Staff Report
City of Richmond, Virginia

Commission of Architectural Review

11. COA-150671-2024	Final Review	Meeting Date: 7/23/2024
Applicant/Petitioner	Benjamin Goodman / James River Construction	
Project Description	New Construction - Rear Garage.	
Project Location:		
Address: 2316 West Grace Street		
Historic District: West Grace Street		
High-Level Details:		
Applicant proposes to construct a new garage in the rear of a brick, Colonial Revival row house ca. 1910.		
The proposed garage will be approximately 21' wide by 24' deep. The foundation material will be Brick & Block 84-86 and there will be a proposed 4" concrete slab. The garage will feature a sloped roof with fiberglass shingling, two (2) double hung fiberglass windows facing the rear yard, one (1) pedestrian door, one (1) paneled garage door, and will have a wall system of Hardiplank siding.		
The garage will have a height of approximately 12' at its maximum.		
Applicant is required to receive a zoning variance to waive lot coverage and setback requirements.

Figure 2. Privacy fence and retaining wall, facing the rear yard from alley.

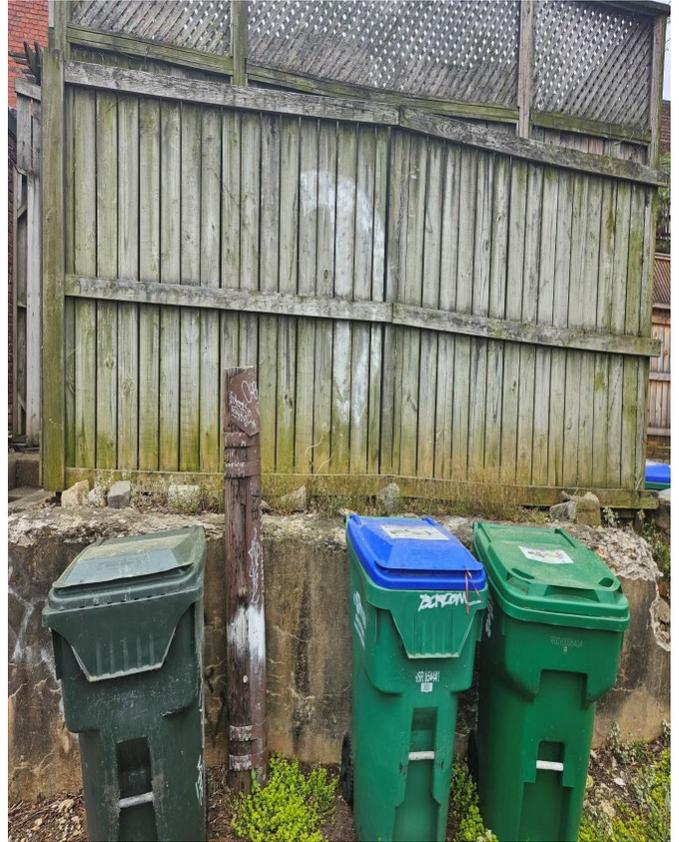
Standards for Site Improvements, Walls & Fences, pg. 78	<p><i>1. Original fences and walls should be retained and maintained whenever possible.</i></p> <p><i>2. Existing brick or stone walls, boxwood hedges, wooden picket fences and cast or wrought iron fences should not be removed or replaced with contemporary features.</i></p>	<p>There is an existing privacy fence and retaining wall in the rear of the property that encloses the back yard. Based on the submitted plans, the construction of the new garage will require this privacy fence and retaining wall to either be entirely or partially removed. Staff finds that the removal of the concrete retaining wall and wooden privacy fence will improve the site to a condition more reflective and matching of the surrounding neighborhoods historic character. <u>Staff recommends that any new privacy fence or retaining wall be submitted for administrative review and approval.</u></p>
